Docket Item # 17
BAR CASE # 2009-0127

BAR Meeting
July 8, 2009

ISSUE: Addition and Alterations
APPLICANT: Cathleen Cotell by Stephanie Dimond
LOCATION: 607 South Fairfax Street
ZONE: RM/Residential

Figure 5. Existing and proposed plans.

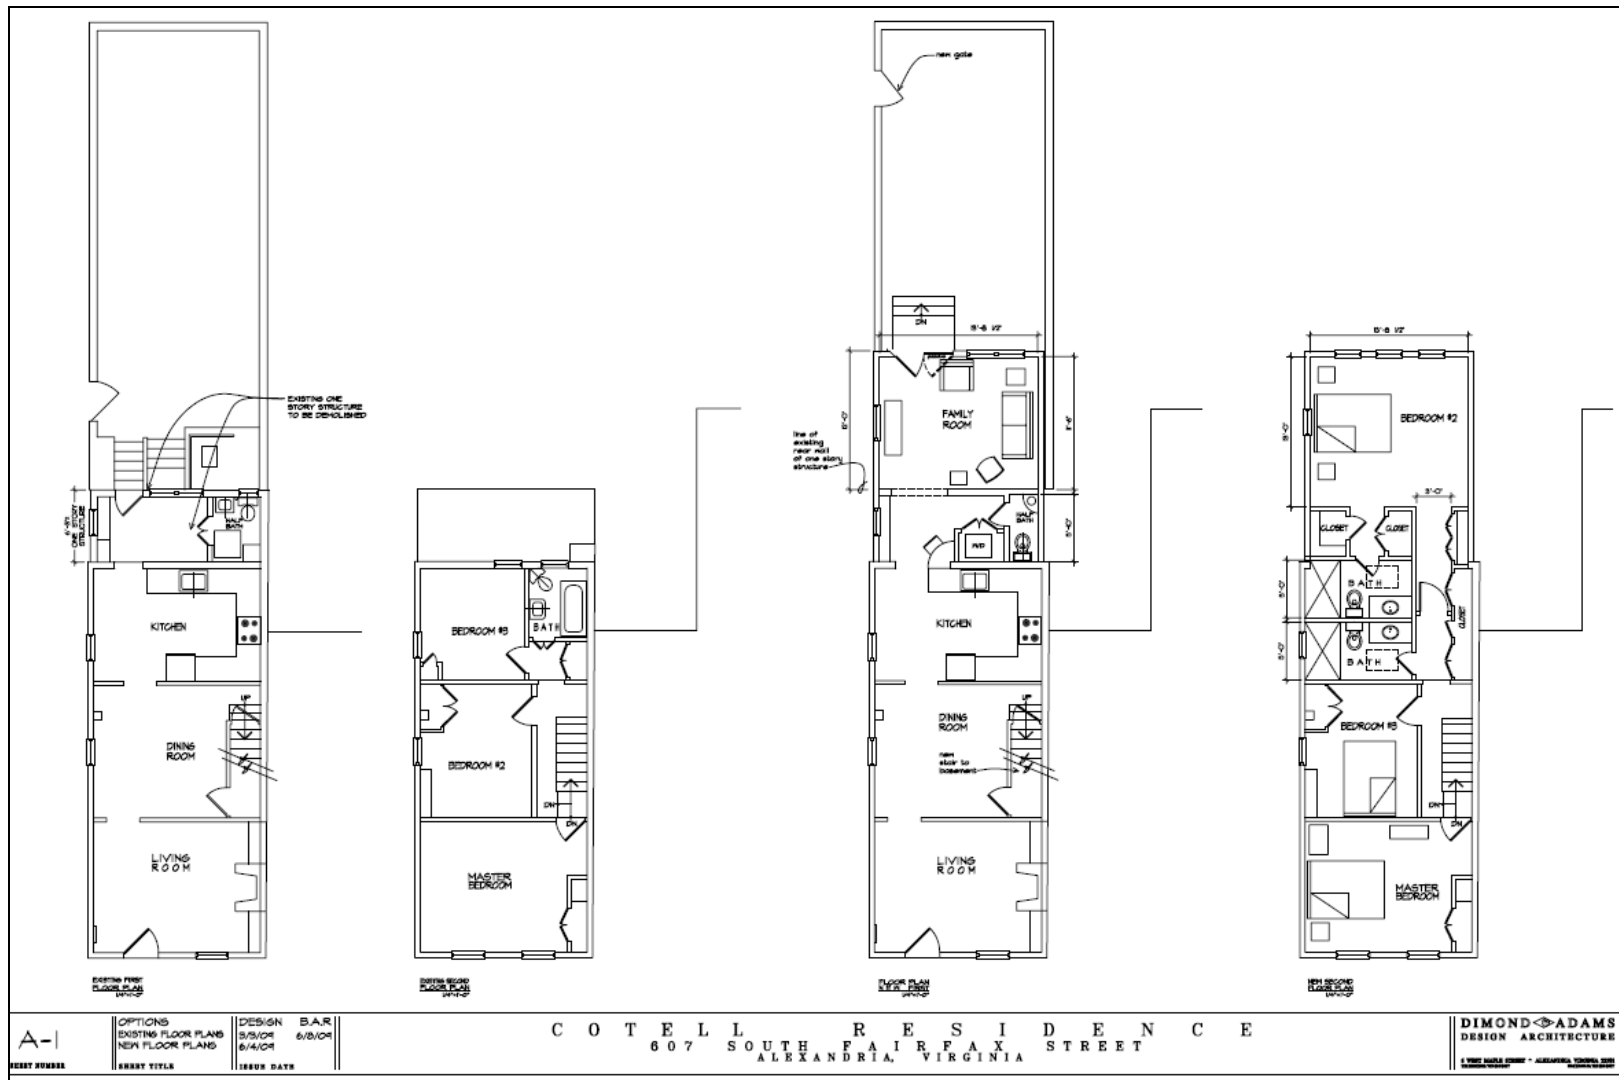
The applicant is requesting approval of a Certificate of Appropriateness for a two-story rear addition and alterations at 607 South Fairfax Street. The proposed addition will measure approximately 14.75 feet in width (slightly less than the width of the existing house) by 18.25 feet in depth.

The proposed addition complies with the requirements of the Zoning Ordinance. The AC unit is proposed to be relocated under the stairs on the addition. Should the applicant propose to relocate the AC to a different location, all zoning and open space requirements must be met.

Figure 7. Proposed elevations.

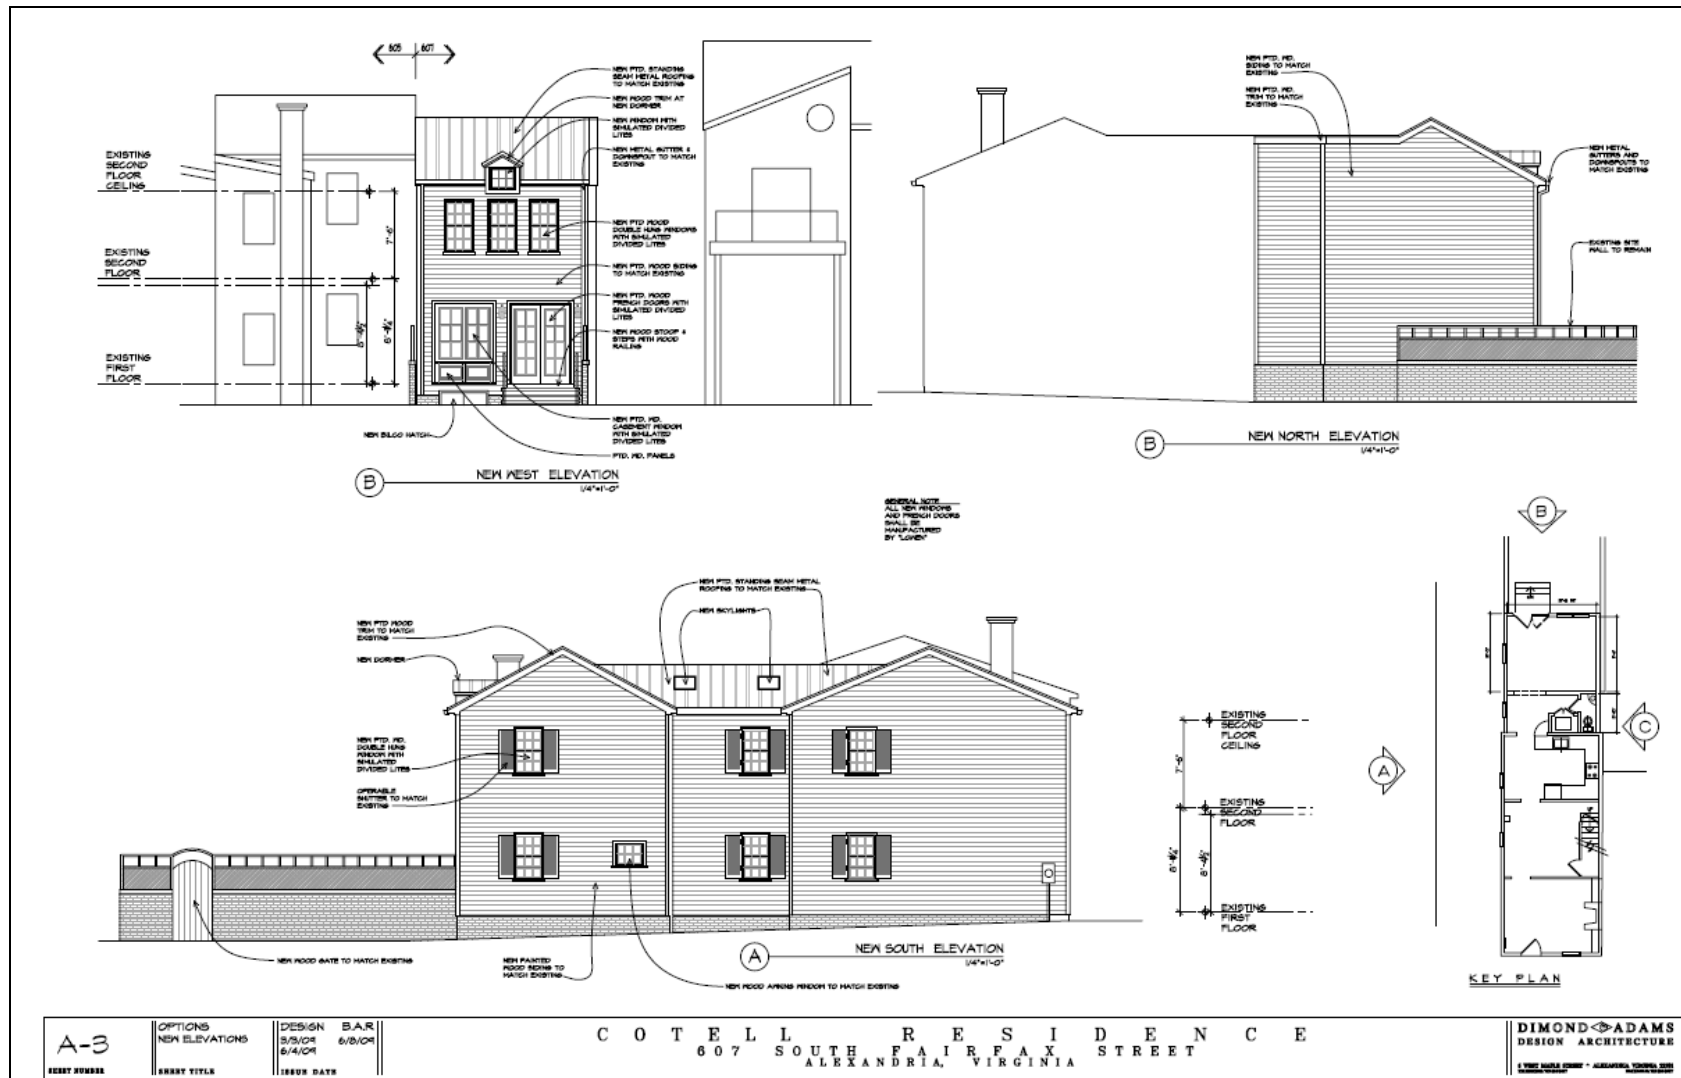
The west (rear) elevation of the addition will have a pair of French doors (wood with simulated divided lights) flanked by two simple light fixtures with wood steps and a wood railing leading to the rear yard. The AC unit will be relocated under these stairs. Also on the first floor will be a pair of wood casement windows with simulated divided lights with wood paneling below. A Bilco hatch (metal) will also be installed to provide access to the basement. The Bilco hatch will be less than two feet above grade and will slope to grade. At the second story will be three simulated divided light, double-hung, wood windows. Above the center window, will be a through-the-cornice dormer. The dormer will have wood trim and a six-light, simulated divided light, wood window. The siding will be wood and will match the existing wood siding on the main block. The roof will be standing seam metal and will match the existing roof. The foundation on the addition will be brick to match the existing brick foundation. A new metal gutter and downspout will be installed to match the existing.

The south (side) elevation will have two, six-over-six, simulated divided light, double-hung wood windows, one on each story. The first story will also have a six-light, simulated divided light wood awning window. The wood trim and operable wood shutters will match the existing house. The existing wood garden gate in the brick wall on the south property line will be relocated approximately 25 feet west, toward the rear of the property.

The north (side) elevation will have no openings. The siding and trim will be wood and will match that on the existing house.

A new gable roof, perpendicular to the gable roof on the main block and to the gable roof on the proposed addition, will connect the two portions over the existing rear element. The proposed new roof will be standing seam metal, to match the existing, and will have two small skylights.

The *Guidelines* note that “skylights should be located on the least visually prominent section of the roof” and that “low or flat profile glass skylights are preferred.” The proposed skylights are relatively modest in size and will be minimally, if at all, visible from the public right-of-way. In addition, the proposed skylights will be flat. The *Guidelines* also note that “skylights must have integral shades that should be used at nighttime to reduce seepage of light visible from the exterior.” Staff recommends that nightshades be installed.

Staff recommends approval of the application with the condition that nightshades be installed on the skylights. Staff also recommends the inclusion of Alexandria Archaeology’s comments.
